SERVICE BULLETIN

N° 139-672

**ATA 29 - NUMBER 4 PUMP LINE INSTALLATION VISUAL INSPECTION AND
MODIFICATION**

This Service Bulletin is issued in order to prescribe an inspection of the auxiliary hydraulic lines and to provide the necessary instruction on how to perform the installation of auxiliary lines retromod P/N 3G2900P00711.

Figure 1

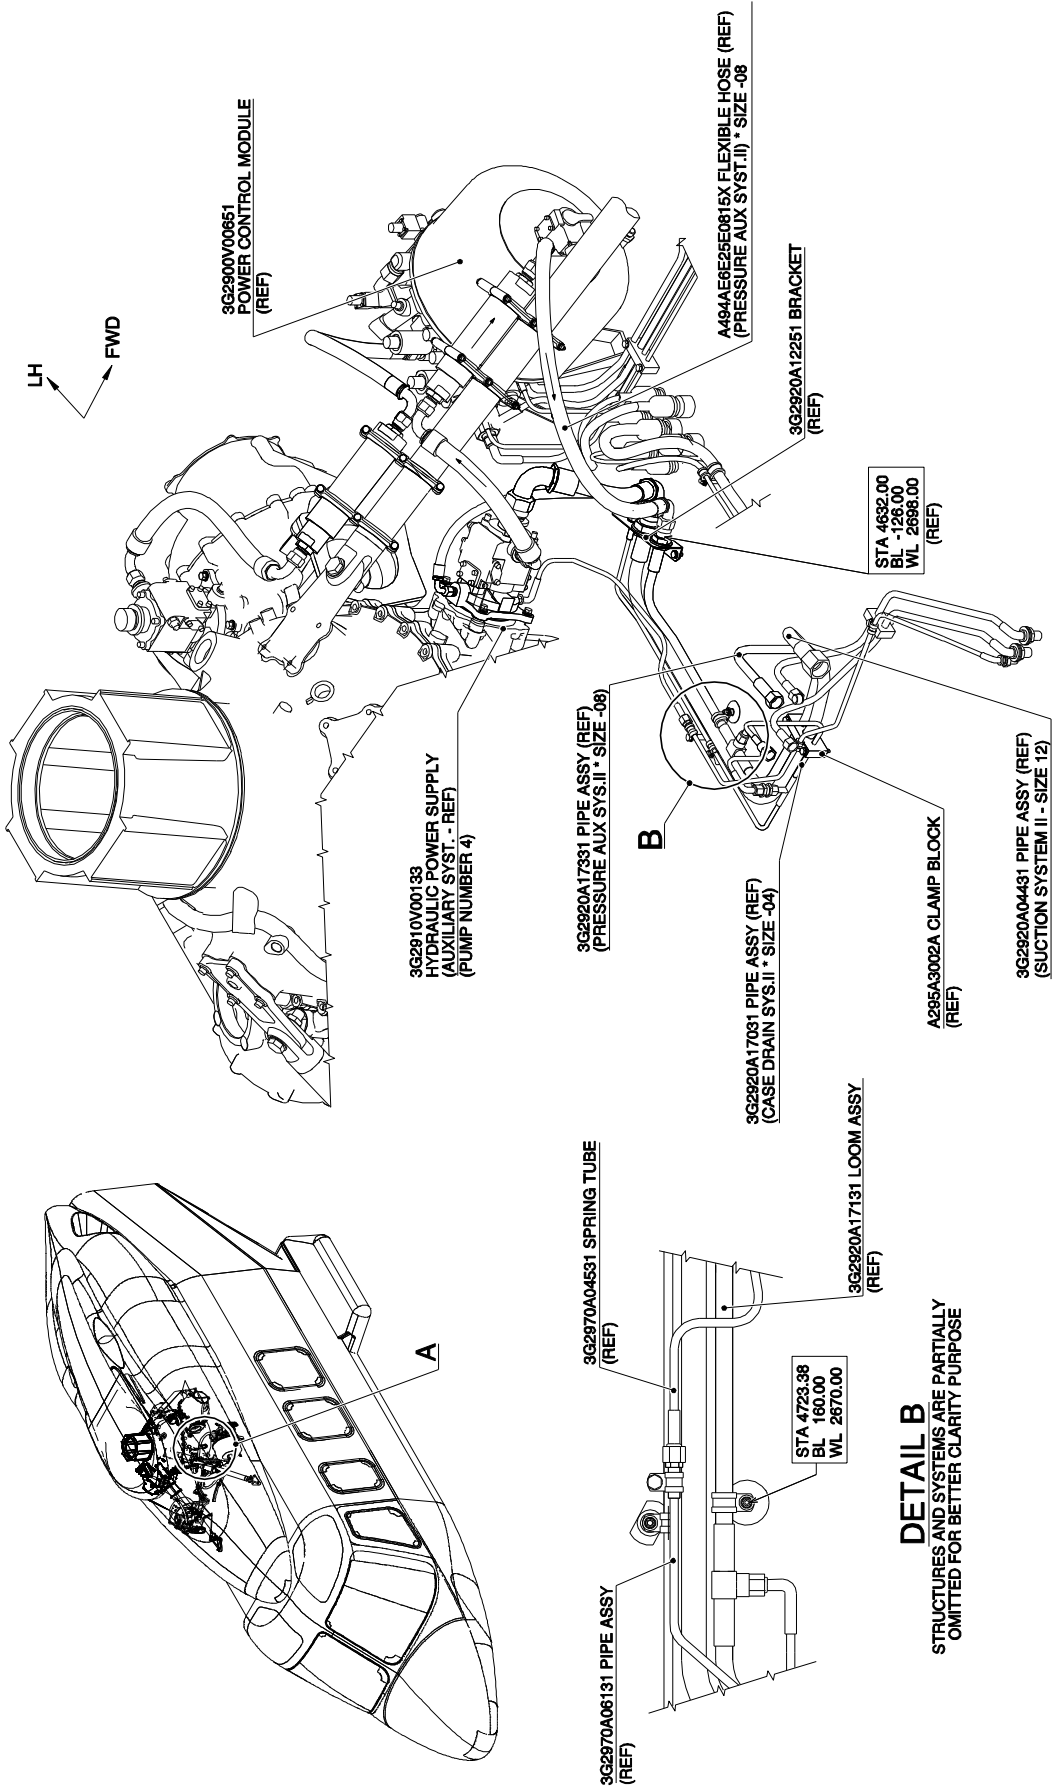
- 7.1 With reference to Figures 1 or 2 or 4, examine the following pipe assemblies for chafing:
- pipe assy P/N 3G2920A17331;
 - pipe assy P/N 3G2920A04431;
 - pipe assy P/N 3G2920A17031.

7. With reference to Figures 1 and 7, disconnect the following pipe and hoses from the side of the bracket P/N 3G2920A12251:
 - Pipe assy P/N 3G2920A17431;
 - Flexible hose P/N A385AG6G00H0255X;
 - Flexible hose P/N A385AB6B69B0436X
 - Flexible Hose P/N A385AB6B33B0295X (if present).

Figure 2

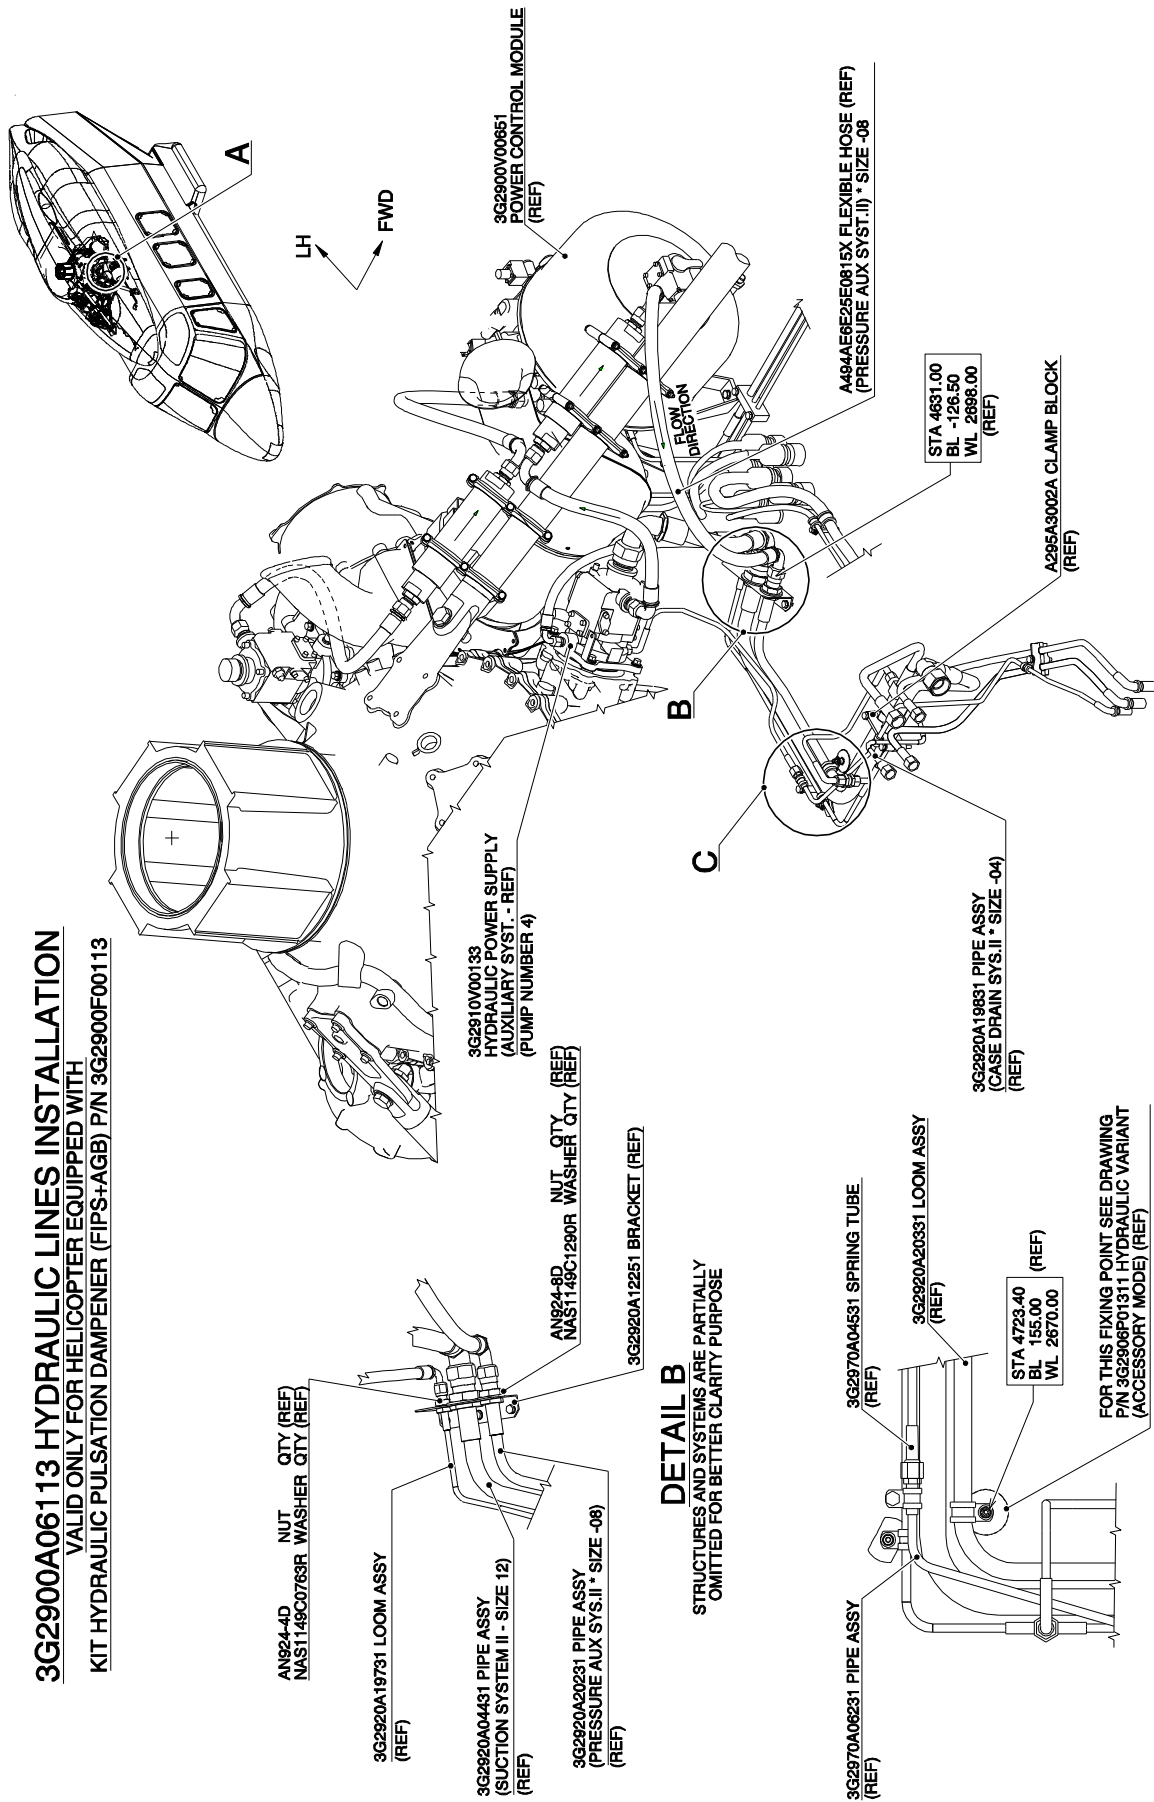
8. With reference to Figures 2 or 3 or 4 or 5 and Figure 7, disconnect the following flexible hoses from the side of the bracket P/N 3G2920A12251:
- Flexible hose P/N A494AE6E25E0815X;
 - Flexible hose P/N A385AG6G00H0255X;
 - Flexible hose P/N A385AB6B69B0436X.

Figure 3

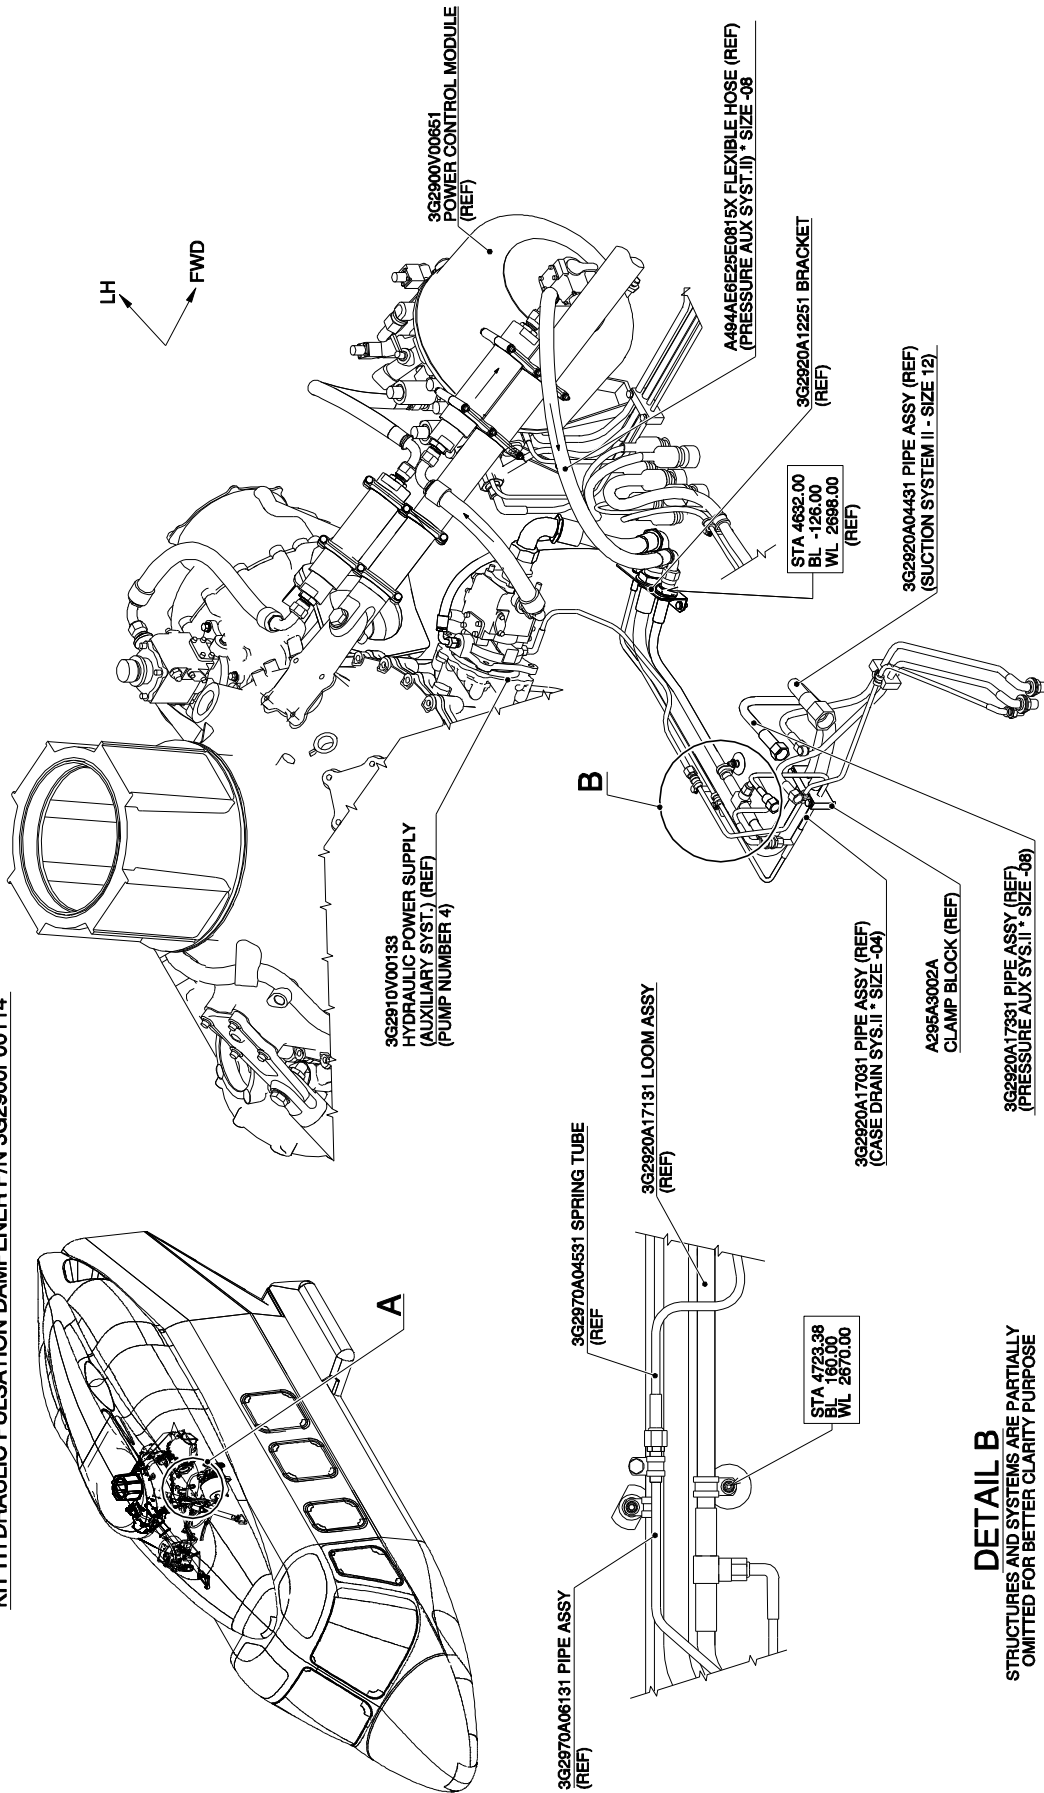
- 7.2 With reference to Figures 3 or 5, examine the following pipe assemblies for chafing:
- pipe assy P/N 3G2920A20231;
 - pipe assy P/N 3G2920A04431;
 - pipe assy P/N 3G2920A19831.

Figure 6

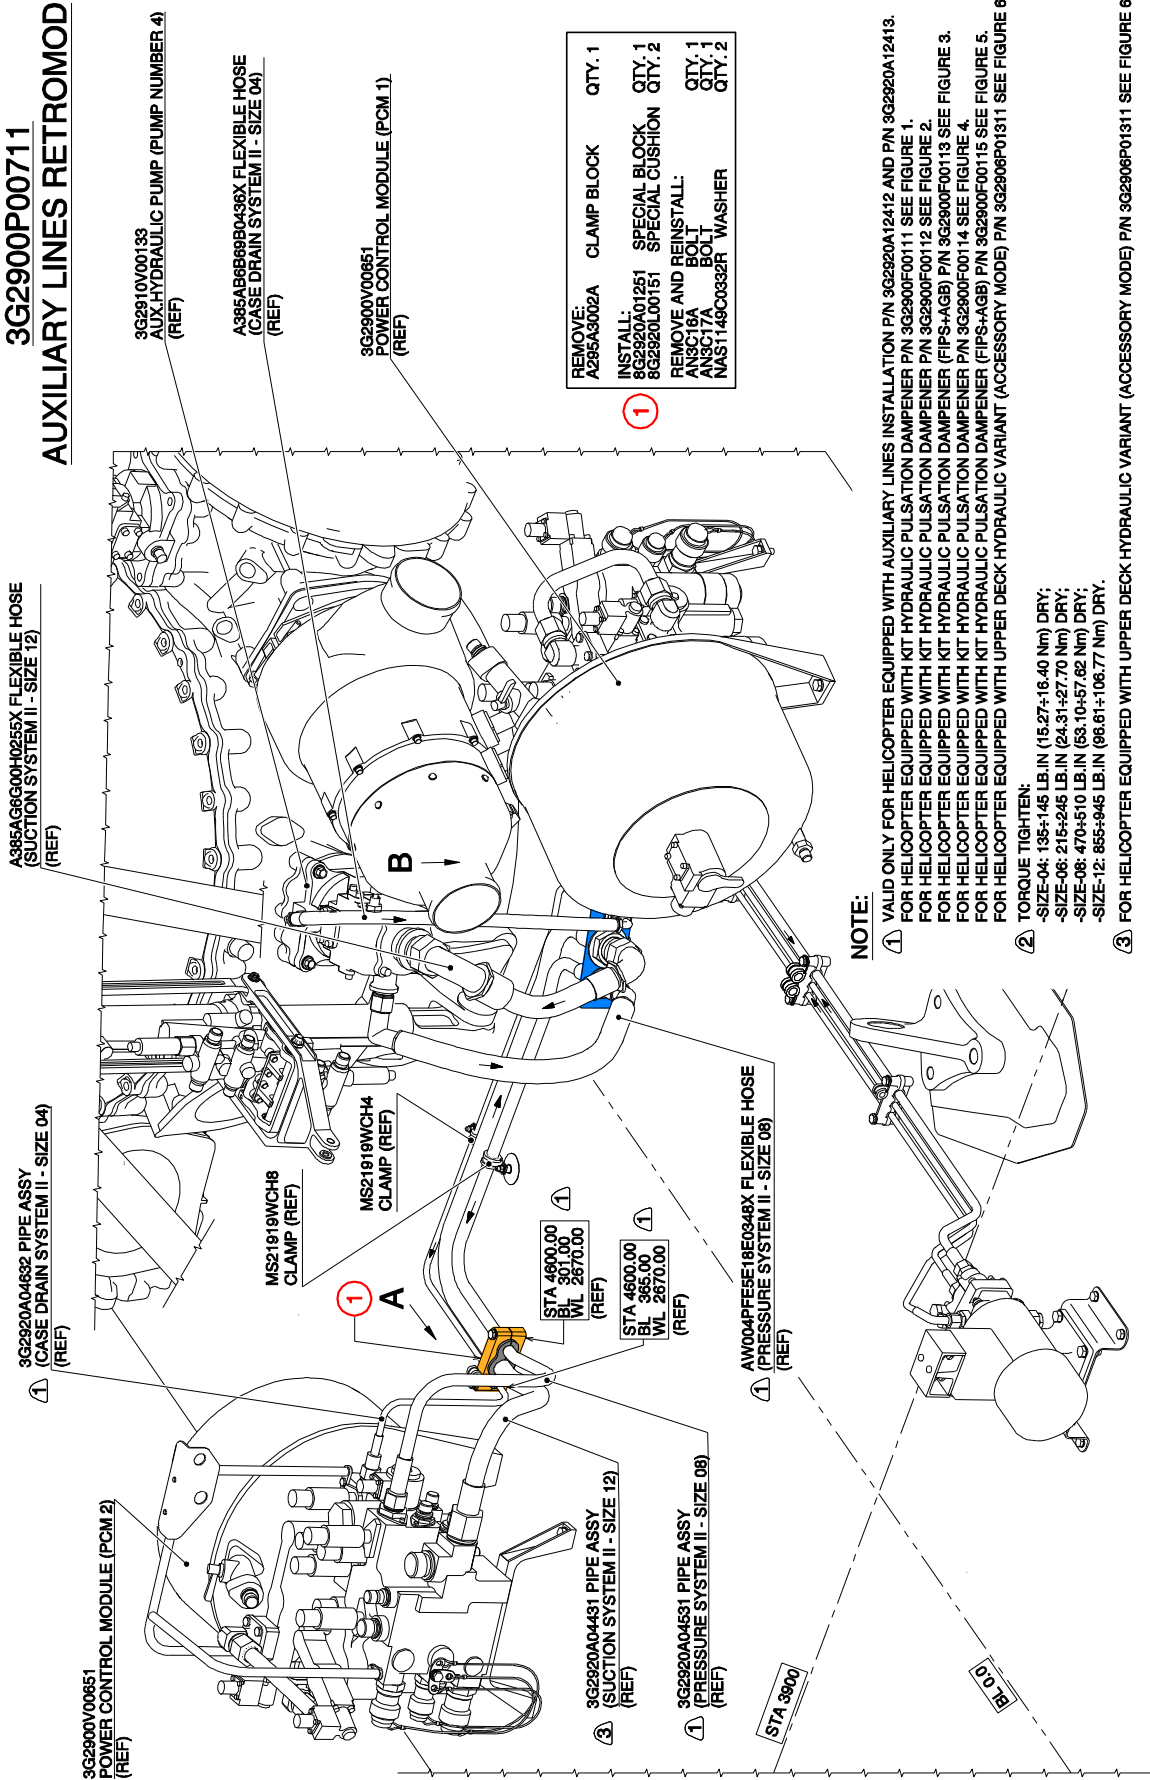
- 7.3 With reference to Figure 6, examine the following pipe assemblies for chafing:
- pipe assy P/N 3G2920A17731;
 - pipe assy P/N 3G2920A17631;
 - pipe assy P/N 3G2920A17831.

9. With reference to Figures 6 and 7, disconnect the following flexible hoses from the side of the bracket P/N 3G2920A12251:
- Flexible hose P/N AW004PFE5E18E0348X;
 - Flexible hose P/N A385AG6G00H0255X;
 - Flexible hose P/N A385AB6B69B0436X;
10. With reference to Figure 8 View B, to release the indicated pipe assemblies from the bracket P/N 3G2920A12251, remove the following fixing hardware:
- at position n°5, remove nut P/N AN924-4D and washer P/N NAS1149C0763R;
 - at position n°6, remove nut P/N AN924-8D and washer P/N NAS1149C1290R;
 - at position n°7, remove nut P/N AN924-12D and washer P/N NAS1149C1790R.
- Retain fixing hardware for later reuse.
11. With reference to Figure 8 View B, remove the bracket P/N 3G2920A12251 and relative fixing hardware from the helicopter.

Figure 7

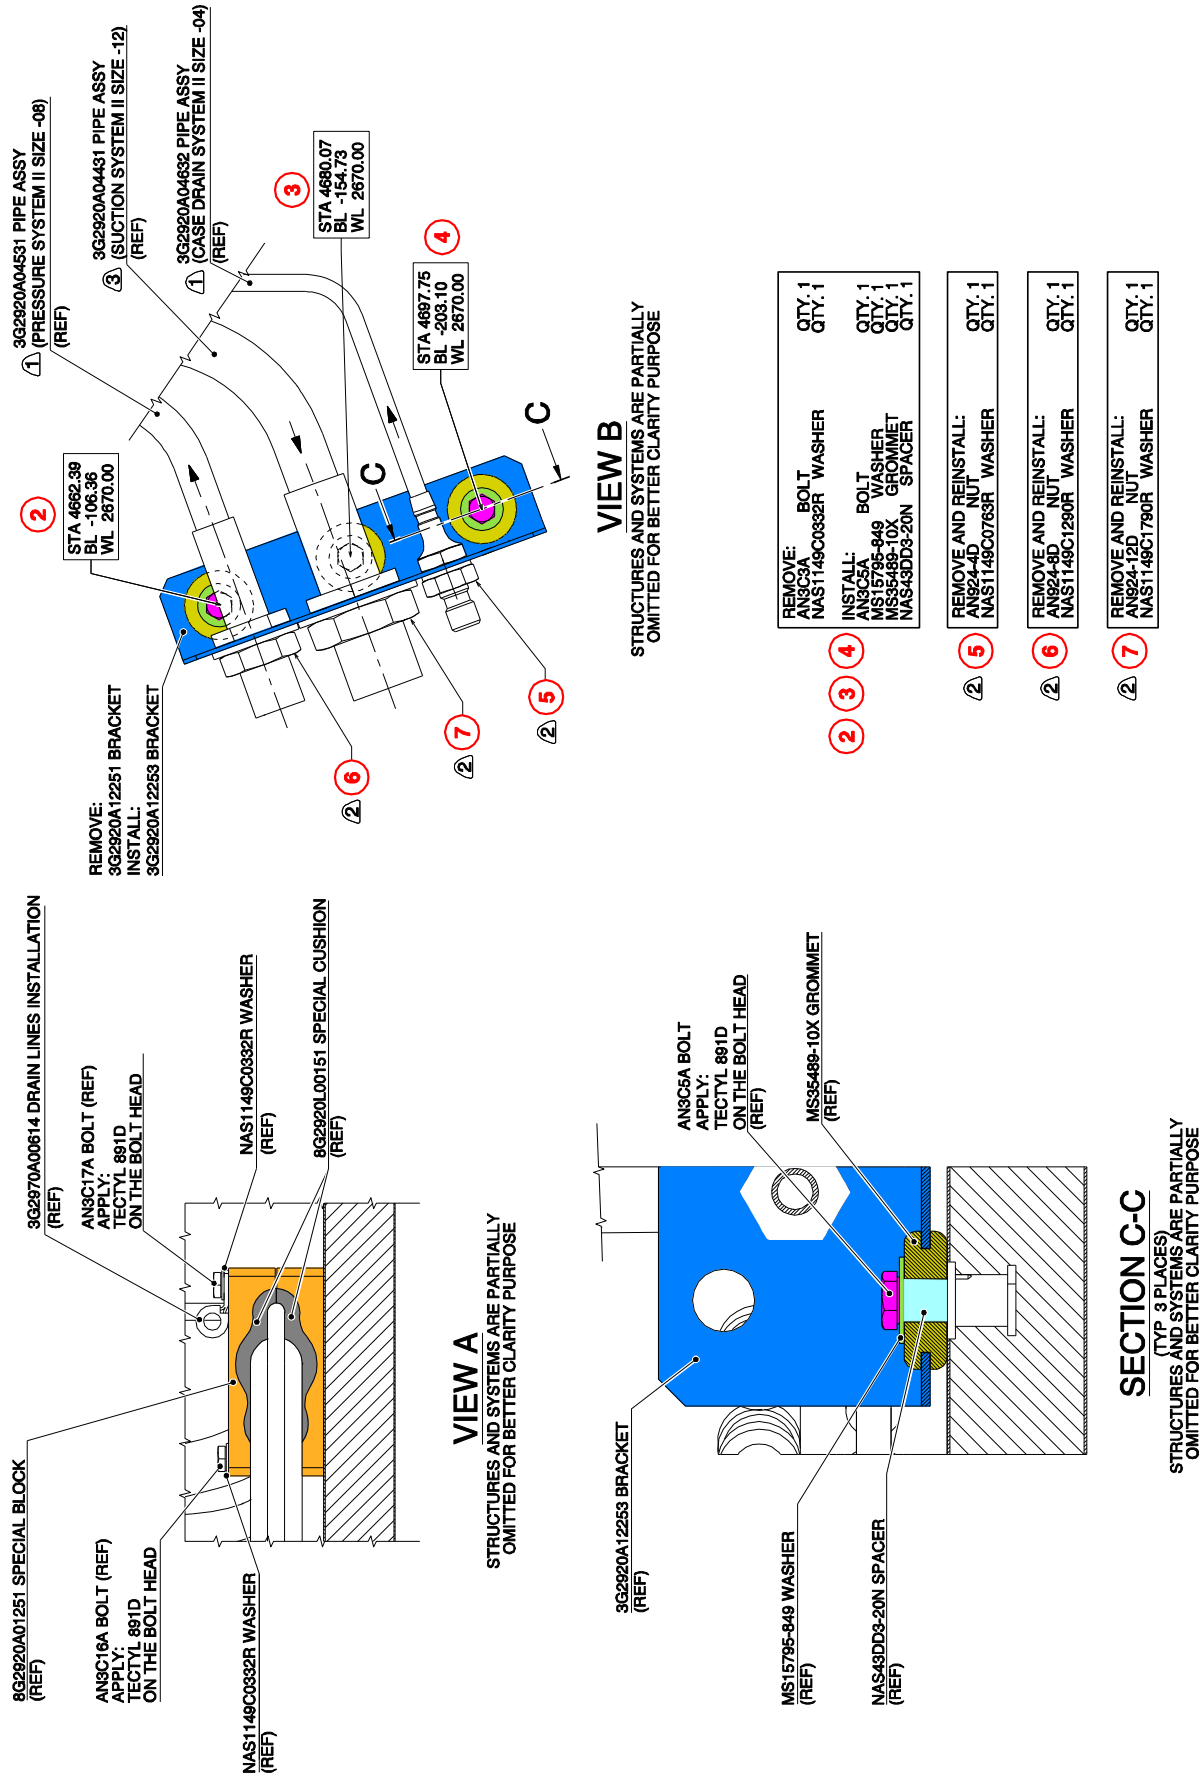
- 7.4 With reference to Figure 7, examine the following pipe assemblies for chafing:
- pipe assy P/N 3G2920A04531;
 - pipe assy P/N 3G2920A04431;
 - pipe assy P/N 3G2920A04632.

4. With reference to Figure 7, at position n°1, remove the clamp block P/N A295A3002A from the helicopter. Retain existing fixing hardware for later reuse.
5. With reference to Figure 7, remove the clamps P/N MS21919WCH8 and P/N MS21919WCH4. Retain for later reuse.
6. In accordance with AMP DM 39-A-12-12-09-00A-228A-A and with reference to Figures 1 thru 7, drain the PCM 2.

18. With reference to Figure 7 and Figure 8 View A, at position n°1, install the special block P/N 8G2920A01251 and n°2 special cushions P/N 8G2920L00151 by means of bolt P/N ANC16A, bolt P/N ANC17A and n°2 washers P/N NAS1149C0332R.
19. With reference to Figure 8 View A, coat exposed bolt heads with corrosion inhibitor TECTYL 891D (C385).
20. With reference to Figure 7, re-install the clamps P/N MS21919WCH8 and P/N MS21919WCH4.
